June 24, 1980

Memo to Coal File:

RE: Soldier Creek Coal Company
Hidden Valley Mine
ACT/015/022
Emery County, Utah

TOPSOIL CALCULATIONS

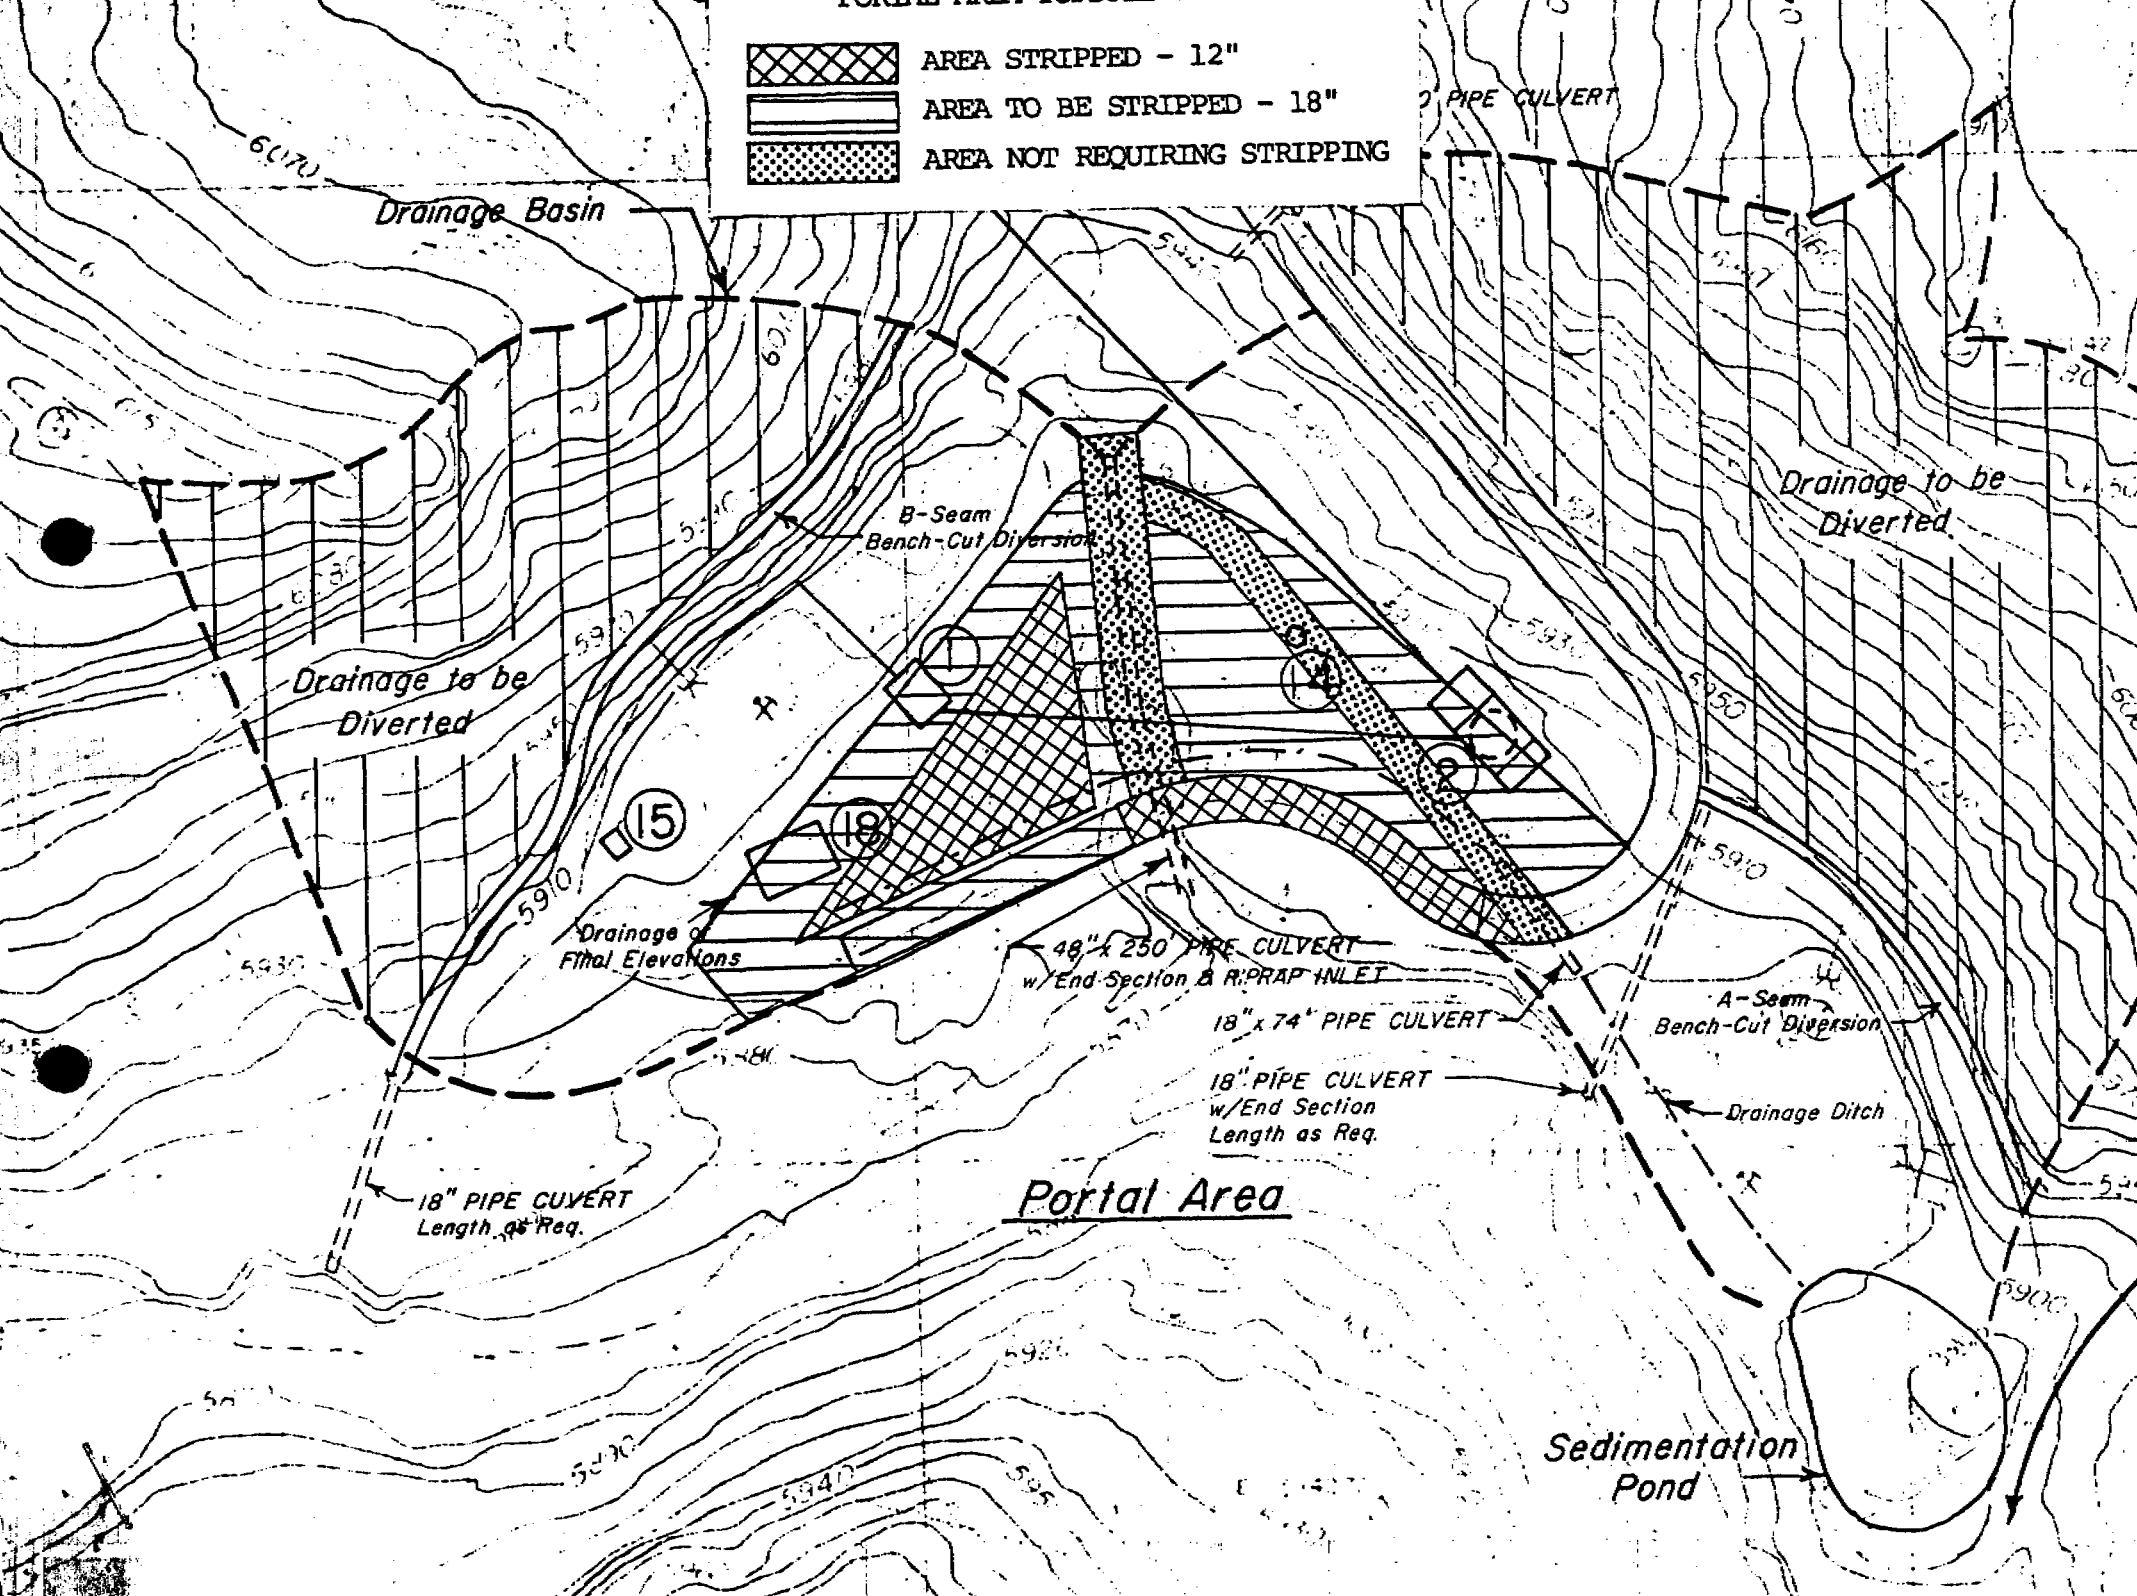
2. Under your personal supervision along with that of the Division of Oil, Gas and Mining staff, remove surface material from the proposed waste storage site and stockpile along with the existing topsoil pile on pad. Remove additional material from this area in order to obtain the necessary 2,157 yd.3 calculated for topsoil removal on the enclosed sheets,

5. Stockpile the topsoil on pre-designated area over the refuse pile. Store with the proper slope ratio to minimize erosion,

6. Construct a ditch on the creek side of the pile and a berm on the upperside to allow the drainage from this area to go through the sedimentation pond before entering the creek,
